SUBJECT: CORRECTION TO OPERATING LICENSE AMENDMENTS (TACS 71963/71964)

My July 18, 1989, letter forwarded Amendments 100 and 82 to Facility Operating Licenses NPF-9 and NPF-17 to the McGuire Nuclear Station, Units 1 and 2. The amendments included revised Technical Specification pages. Please replace page 3/4 4-33 included with that letter with the enclosed corrected page.

FIGURE 3.4-4 MCGUIRE UNIT 1, REACTOR COOLANT SYSTEM, COOLDOWN LIMITATIONS NRC RG 1.99 REV 2 APPLICABLE FOR THE FIRST 10 EFPY

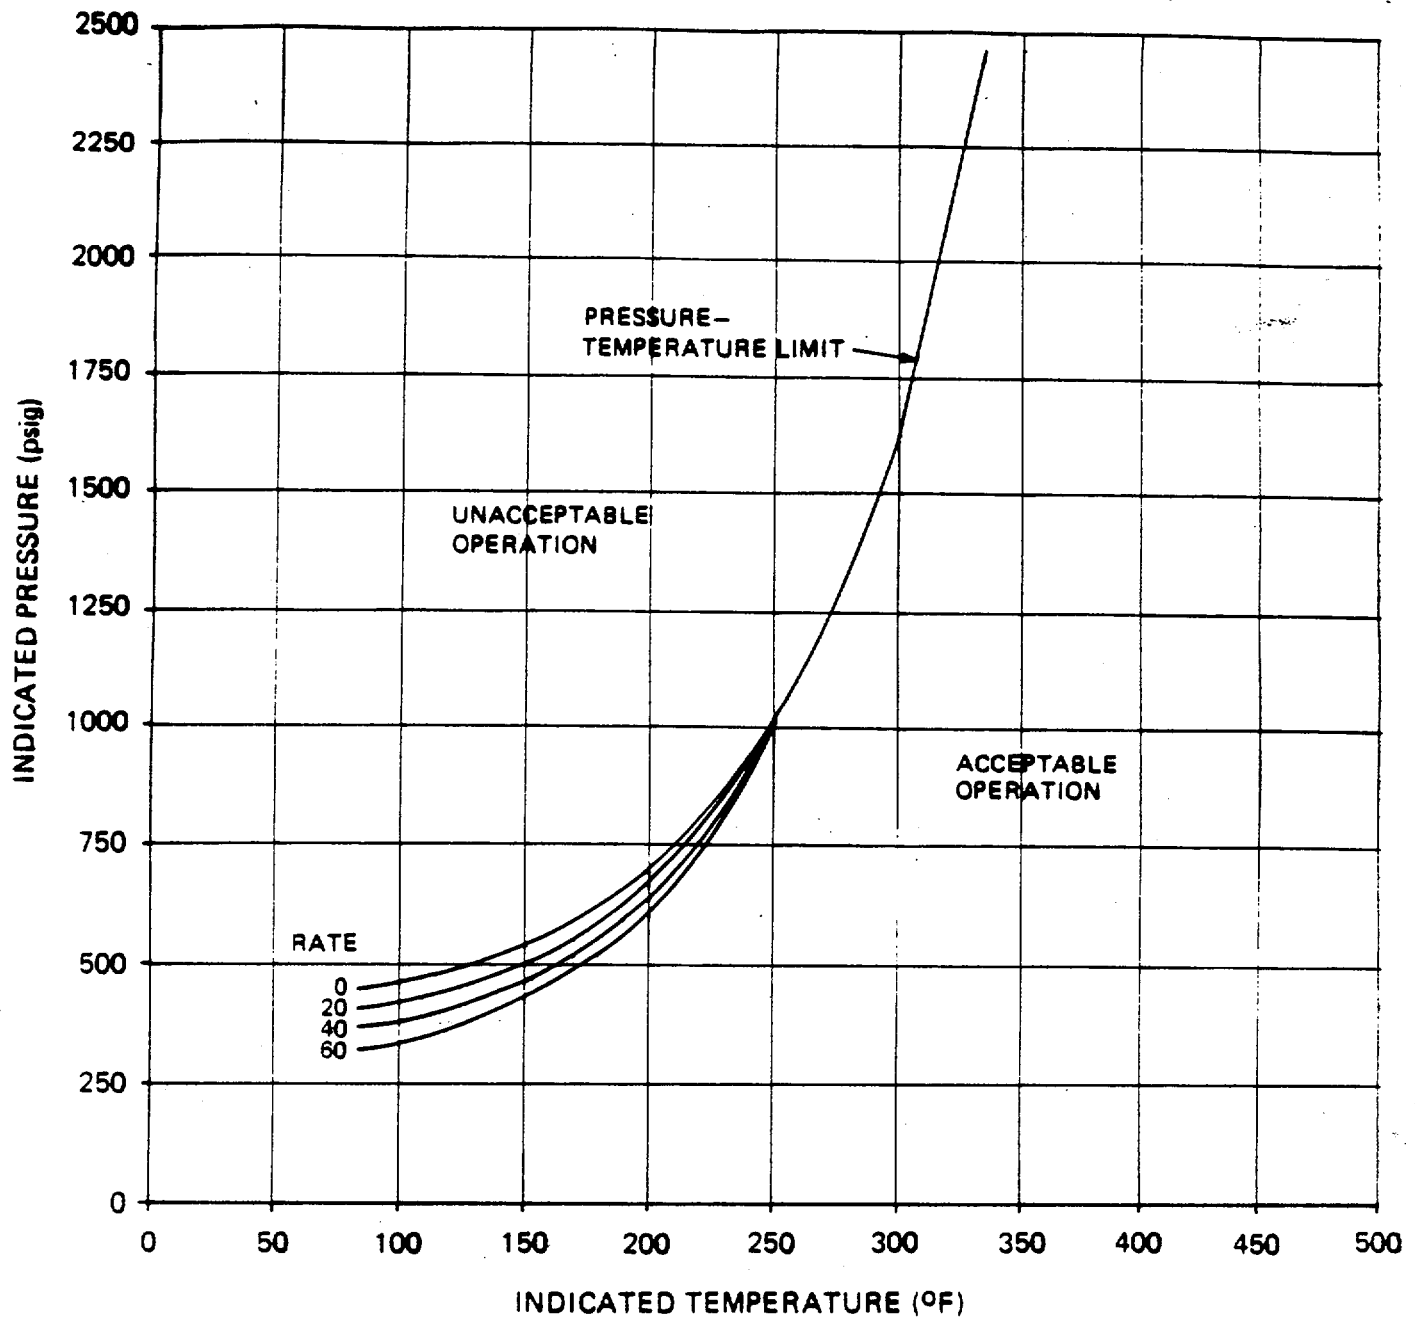
My July 18, 1989, letter forwarded Amendments 100 and 82 to Facility Operating Licenses NPF-9 and NPF-17 to the McGuire Nuclear Station, Units 1 and 2. The amendments included revised Technical Specification pages. Please replace page 3/4 4-33 included with that letter with the enclosed corrected page.
